**Buffer Zone Contamination Review
(Additional Assessment)**

**Prepared by the
Colorado Department of Public Health and
Environment**

An Assessment of Site Disturbances at RFETS, April, 2003

This report is an update to Buffer Zone Contamination Review, A Review of Information Related to Contamination of the Rocky Flats Buffer Zone, prepared by David Kruchek, CDPHE. The purpose of this report is to follow up on those items noted in the prior report and the Site's responses and review additional material to investigate site disturbances, not part of existing Individual Hazardous Substance Sites or areas already designated for action under RFCA, to determine how they were or will be evaluated relative to potential contamination concerns, and to document their cause, when they may have occurred and final actions taken.

Item 20: 1962 Aerial Photo

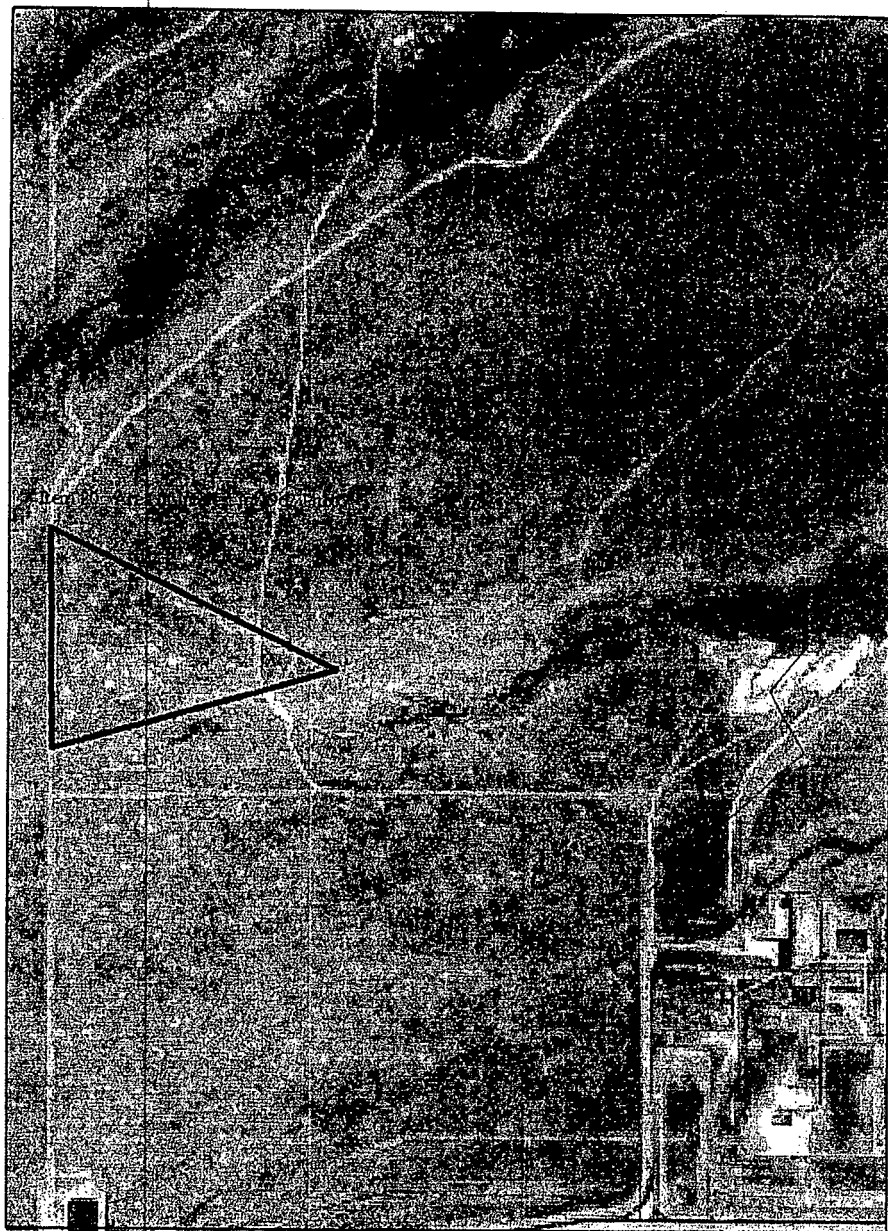
Item 20, the general conclusion is these areas are indeed either active prairie dog mounds or remnants of their occupation. As these remnants are noted prior to the IA and the explanation in DOE 2001, is likely except for two areas.

Two areas, one noted in the 1962 photo and another noted in the 1969 photo show paths created by vehicles. (See photos attached). Furthermore, the size of the circles has changed particularly for the area covered in the 1969 photos. More importantly the 1969 photo examined stereoscopically at Colorado Aerial Photo show shadows made from vertical cylindrical manmade objects. These objects would be considerably larger than drums. Therefore, these areas are in need of further investigation to determine the nature of the disturbances. The disturbances are still prominent in 1970, but not by 1978. This information was presented to the stewardship group at DOE for their examination.

7/29/1983 Photo: Additional Area of Interest 2.

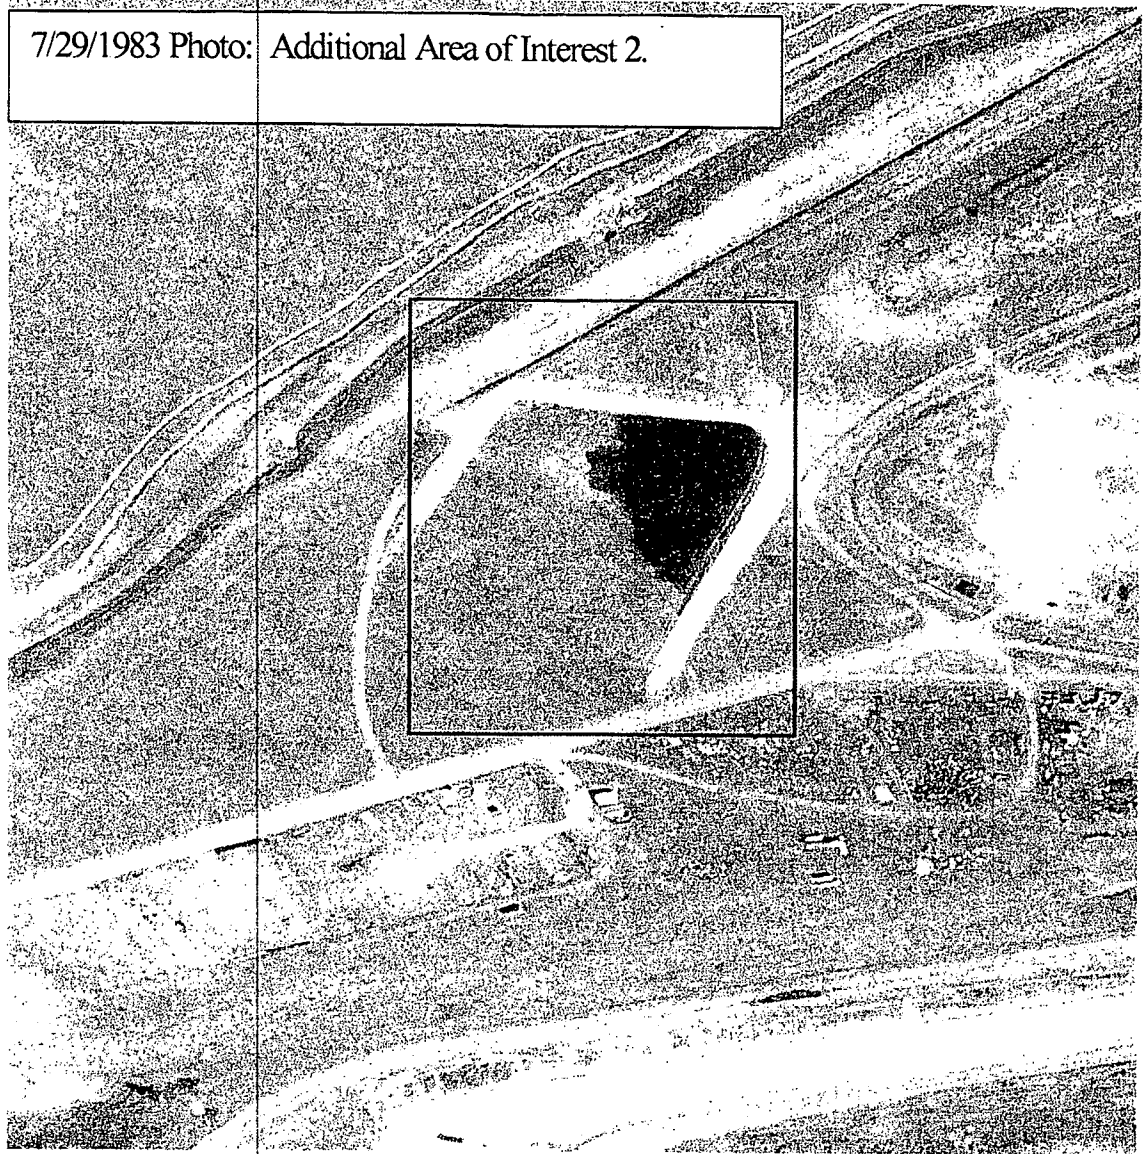
2. The 7/29/1983 aerial photo shows a constructed water holding area west of the present landfill. The purpose for and contents of this activity need to be documented and possibly investigated. (See photo attached)

7/1/1969 Photo: Additional Area of Interest 3.

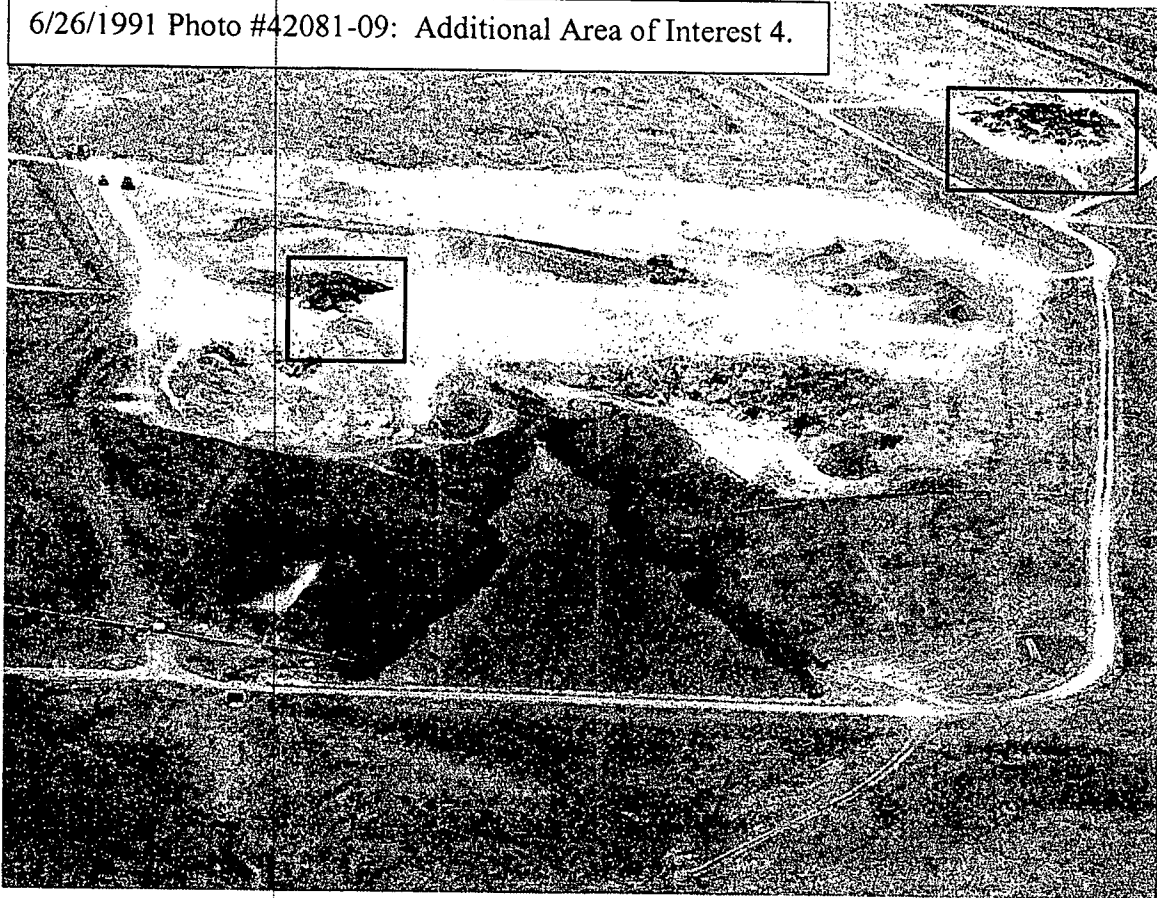
3. The 7/1/1969 photo shows 2 disturbed areas due east of the present landfill and slightly south. What these disturbances were caused by needs to be documented and possibly investigated. (See photo attached)

6/26/1991 Photo #42081-09: Additional Area of Interest 4.

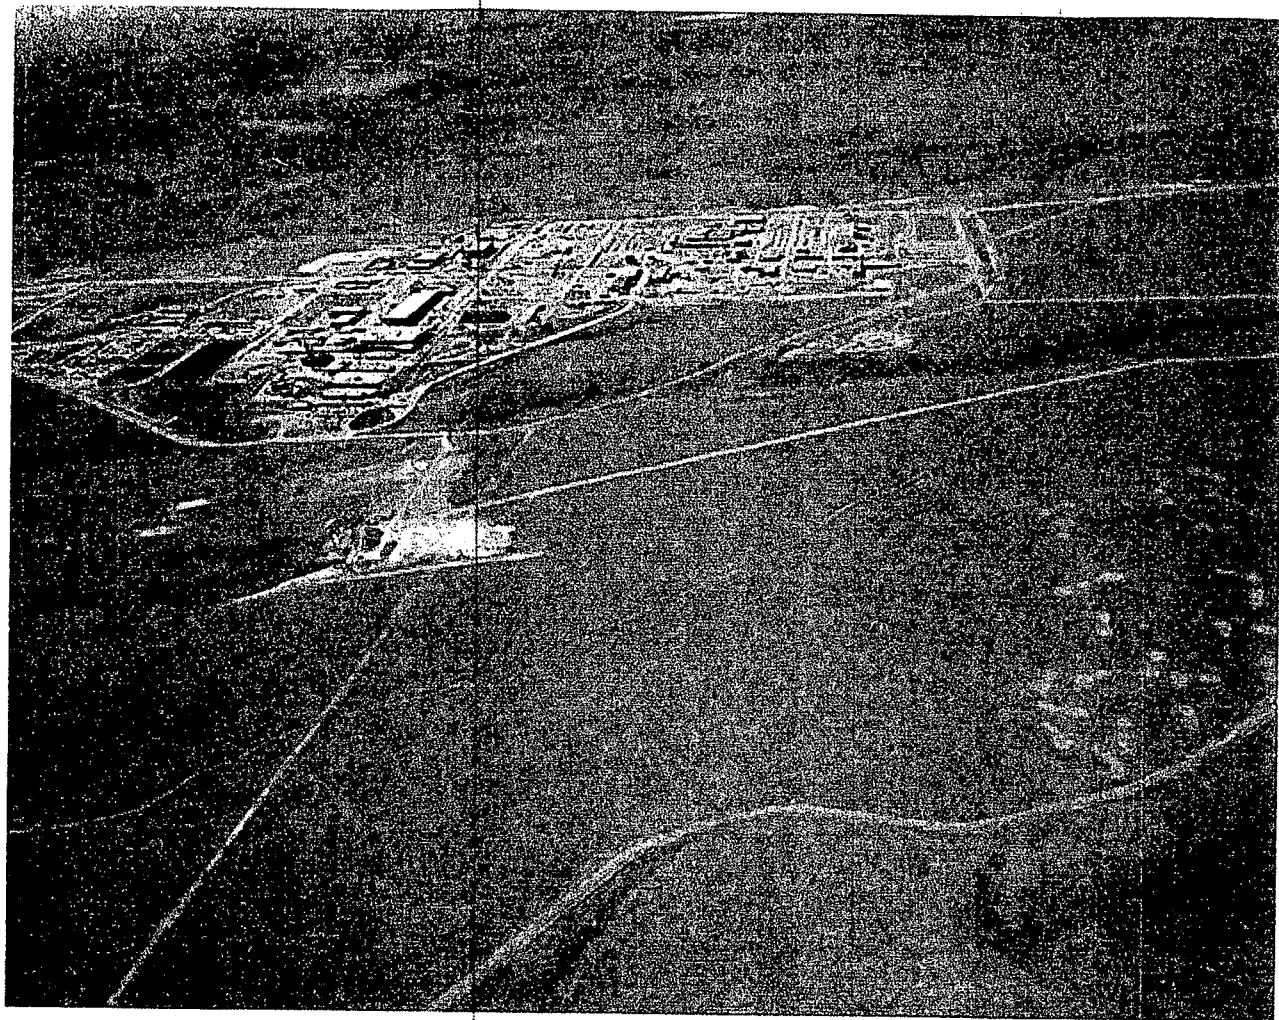
4. The 6/26/1991 photo 42081-09 shows two dark mounds of material one north and one west of the present landfill. The material is possibly asphalt. What this material is, where it came from and what its ultimate disposition was needs to be investigated and documented.
